CHICAGO INCINERATOR FACILITY

**FINAL
RCRA FACILITY INVESTIGATION
REPORT**

**APPENDIX R
RESPONSES TO USEPA COMMENTS**

ATTACHMENT 1
TECHNICAL REVIEW OF RFI REPORT FOR
THE CWMCS CHICAGO INCINERATOR FACILITY

PHASE 1 GROUNDWATER VOLATILES

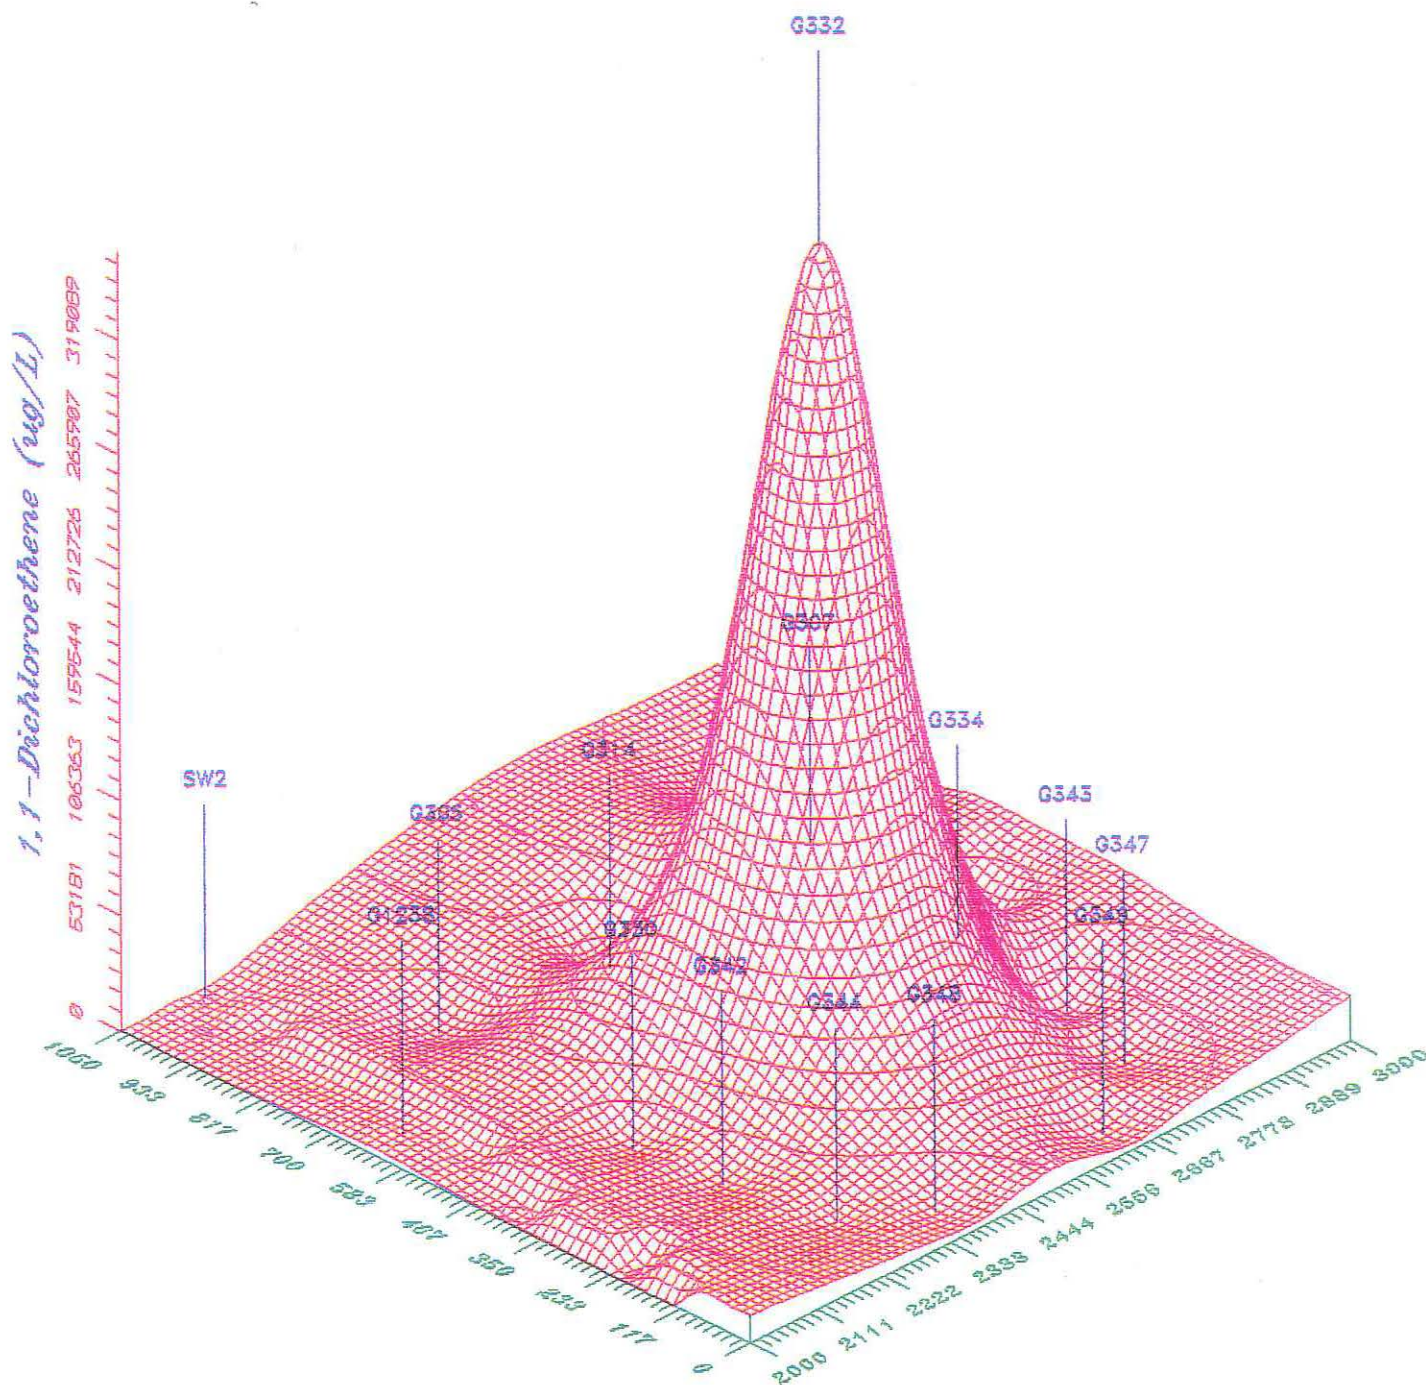
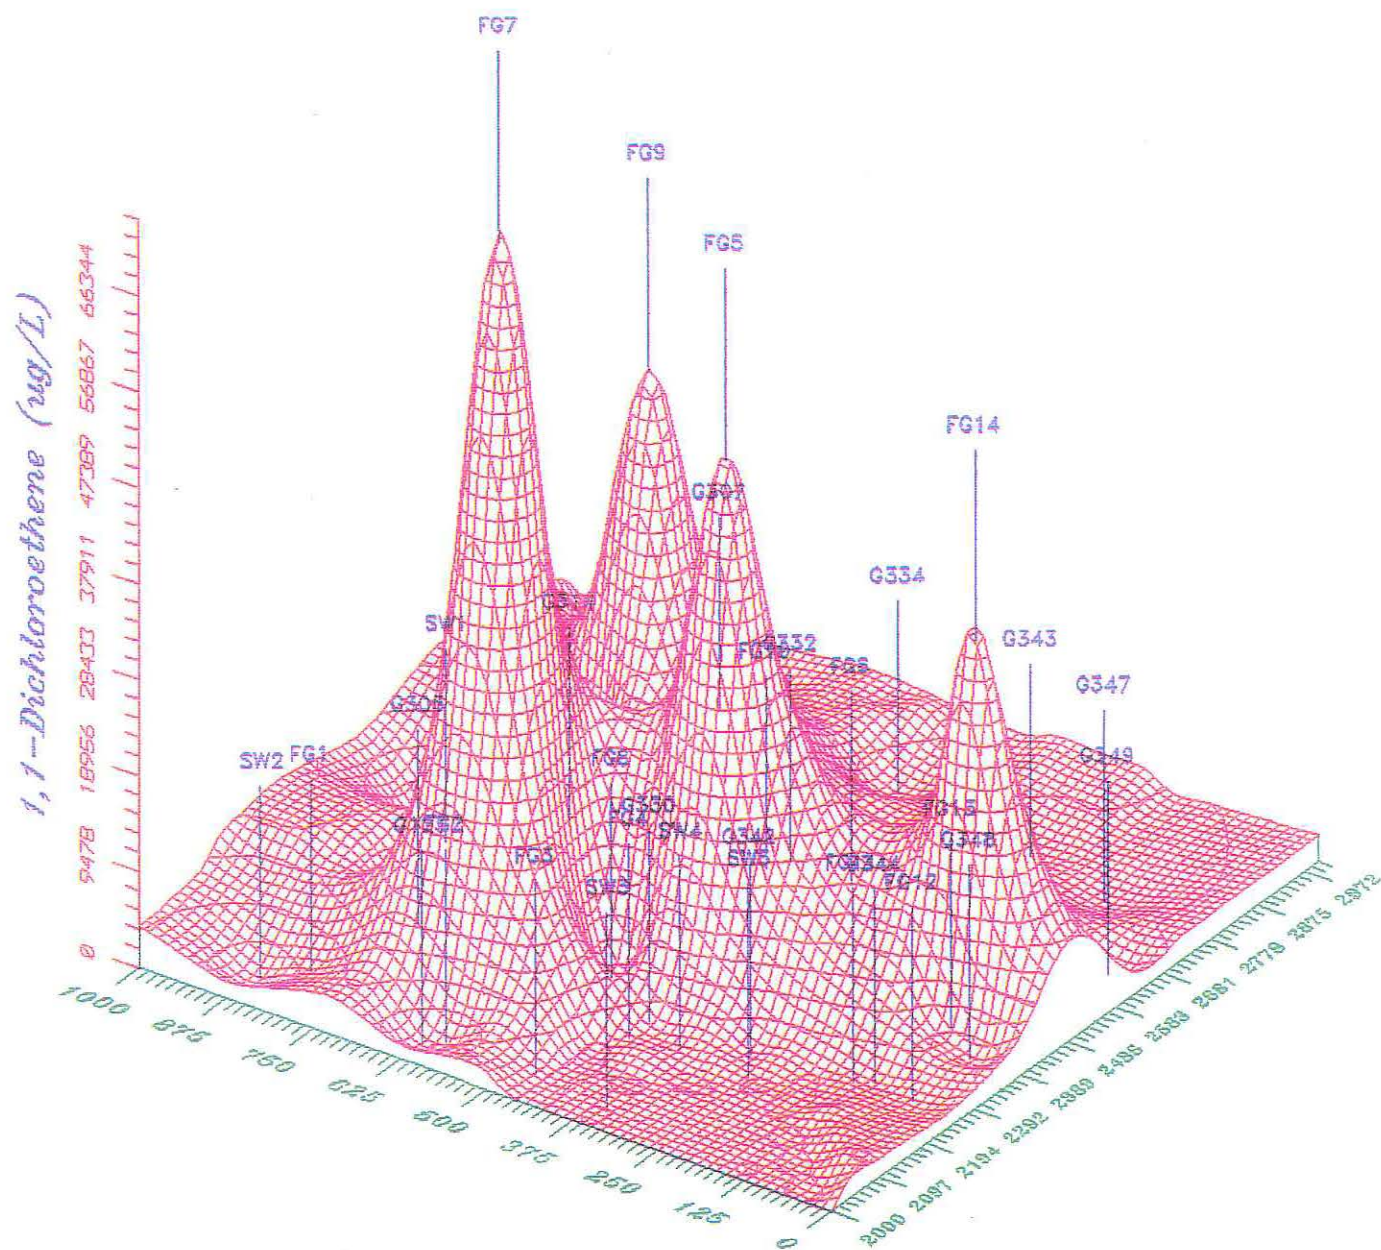
6. **Comment:** Section 4.2.4, Page 4-62. *The text states "These logarithmic iso concentration maps all indicate that concentration of organic compounds decrease significantly away from the SWMUs". Not only is this statement unclear, it is inconsistent with CWMCS conclusion in the preceding section. U.S. EPA requests that these concentration maps be redrawn using real (non transformed) concentration values to allow for better pictorial representation of actual conditions around each SWMU.*

A logarithmic scale was used on these isoconcentration maps to show that levels of contamination are high within the boundaries of the former SWMUs. Concentrations
